Re: Yakima Storage Study, Draft Planning Report/Environmental Impact Statement

Comments on Yakima River Basin Water Storage Feasibility Study, Draft Planning Report/Environmental Impact Statement (January 2008)

Review of the Black Rock and Wymer Dam Sites Geology as Presented in the
Draft Planning Report/Environmental Impact Statement
Yakima River Basin Water Storage Feasibility Study

Figure 1. Faults and folds (red lines) in south-central Washington State. Note the proximity of major fault and fold structures to the proposed Black Rock and Wymer dam sites (indicated by black bars). Map is taken from Lidke, *et al.* (2003).

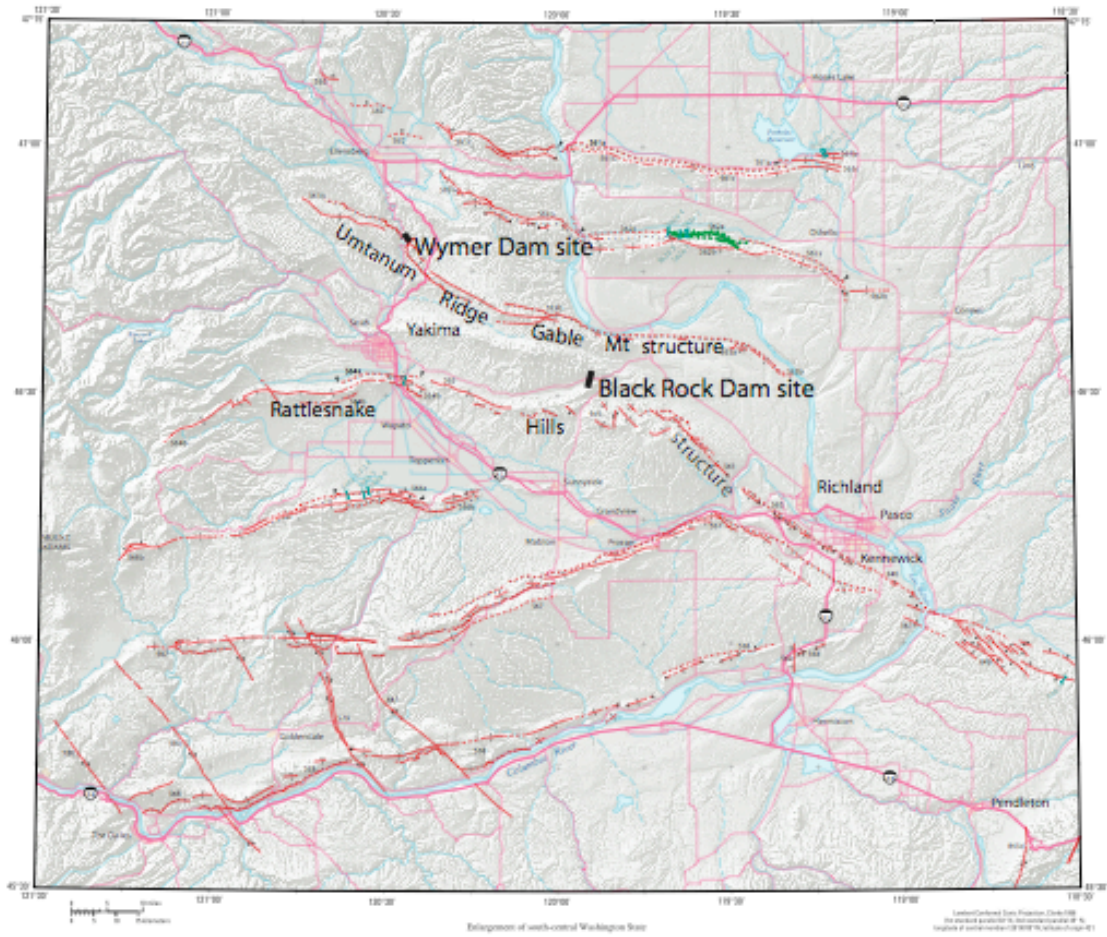
A cursory examination of the USGS fault map (Figure 1) shows that the Umtanum Ridge – Gable Mountain Structure, a 200 km long fault and fold system, runs only a kilometer to the west of the dam site, just across Highway 821 (Lidke *et al.*, 2003). The PSHA study included this fault system in its assessment of the Black Rock Valley site PHA. The failure of the draft EIS here to note the proximity of this major fault to the Wymer dam site renders the draft EIS inadequate, and does not build confidence in the seismic hazard evaluation process.

The most common orientation of the faults and folds in the Yakima Fold Belt is east–west, but the Umtanum Ridge – Gable Mountain Structure strikes northwest–southeast near the Wymer dam site (Figure 1; Reidel *et al.*, 2003). This part of the fault structure may be associated with the Olympic-Wallowa lineament, an alignment of faults and folds that may represent a fundamental, crustal scale discontinuity (*e.g.*, Reidel *et al.*, 1994). The different orientation of the Umtanum Ridge – Gable Mountain Structure near the dam site, and its possible association with the Olympic-Wallowa lineament, suggests the fault near the dam site may respond to the regional stress differently than the faults near the Black Rock Valley site (*e.g.*, with different recurrence times or different size earthquakes). This suggests that an independent seismotectonic analysis of the Wymer dam site must be performed before the EIS can be considered adequate.
